Access Compliance Report

Public Rights-of-Way

(Curb Ramps)

Intersection ID: 14863	Main Street: WEST_BV	Cross Street: AIRPORT_DR	Location:	N
ADA ID: E40088C88E95	Ramp Type: PerpDiag	Initial Pass/Fail: Fail	Overall Compliance: No	Severity Score: 26.25
Codes/Mitigation Info/Possible Solution		Field Measurements/Component Compliance

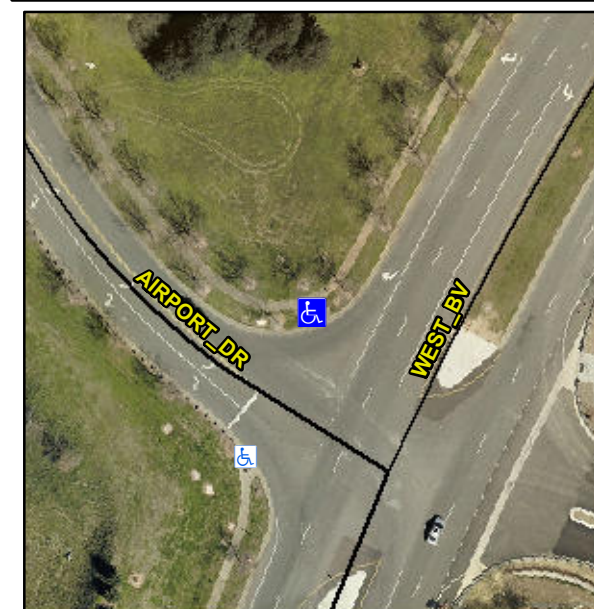
Not Found, R304.2.2, R304.5.3

Compliance	Description	Data	Compliance	Description	Data
N/A	Ramp Length (in)	64.0	No	Ramp Slope (%)	12.8
Yes	Ramp Width (in)	48.0	No	Ramp XSlope (%)	3.7
N/A	Flare Type LT	N/A	N/A	Flare Type RT	N/A
N/A	Flare Slope LT (%)	N/A	N/A	Flare Slope RT (%)	N/A
N/A	Flare Traversable LT?	N/A	N/A	Flare Traversable RT?	N/A
N/A	Landing Length (in)	N/A	N/A	DWS Provided?	N/A
N/A	Landing Width (in)	N/A	N/A	DWS Contrast?	N/A
N/A	Landing Slope (%)	N/A	N/A	DWS Length (in)	N/A
N/A	Landing X Slope (%)	N/A	N/A	DWS Full Width?	N/A
N/A	Landing Curb? (Y/N)	N/A	N/A	DWS Offset (in)	N/A
N/A	Shared Landing?	N/A			
N/A	Gutter Ponding?	N/A	N/A	Gutter Slope (%)	N/A
N/A	Gutter Lip Ht (in)	N/A	N/A	Gutter X Slope (%)	N/A
N/A	Painted X Walk1?	No	N/A	Painted X Walk2?	No
	X Walk 1 Direction	To SW		X Walk 2 Direction	To SE
N/A	X Walk 1 Width (in)	N/A	N/A	X Walk 2 Width (in)	N/A
	X Walk 1 Slope (%)	2.4		X Walk 2 Slope (%)	4.2
	X Walk 1 X Slope (%)	4.7		X Walk 2 X Slope (%)	2.2

Remove & Replace Curb Ramp With Two New Directional Ramps or Equivalent.
